<b>Subject:</b>  FRONT BRAKE SQUEAK WHEN COLD	<b>Bulletin No:</b> 04-007/06
	<b>Last Issued:</b> 9/1/2006

## BULLETIN NOTE

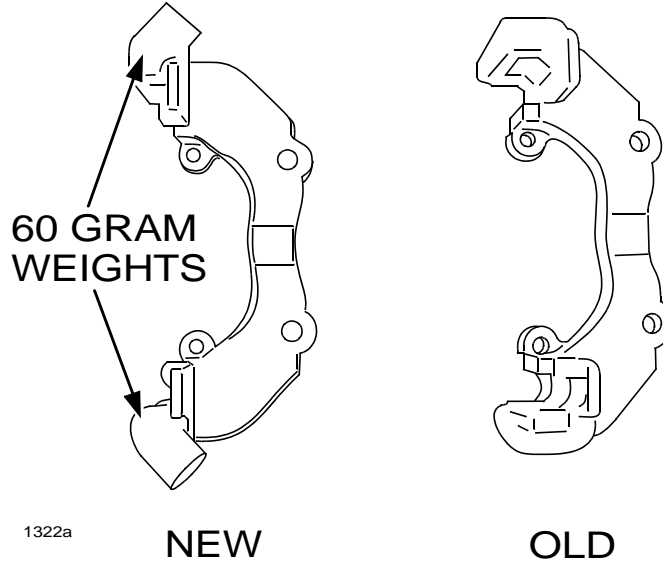
- If service bulletin 04-001/05 was already performed on this vehicle, the updated caliper mounting supports will already be installed. Verify that the updated supports are installed through visual inspection.
    - If updated caliper mounting supports are not installed, continue with REPAIR PROCEDURE "A".
    - If updated caliper mounting supports are installed, proceed to REPAIR PROCEDURE "B".
2. Replace front brake caliper mounting support assemblies and front pad & shim set with the modified parts

according to Workshop Manual (section 04-11 FRONT BRAKE (DISC) REMOVAL/INSTALLATION).

- Use new bolts 9975-60-230, two (2) per mounting support. The thread pitch is different than original. Do not reuse original mounting support and bolts.
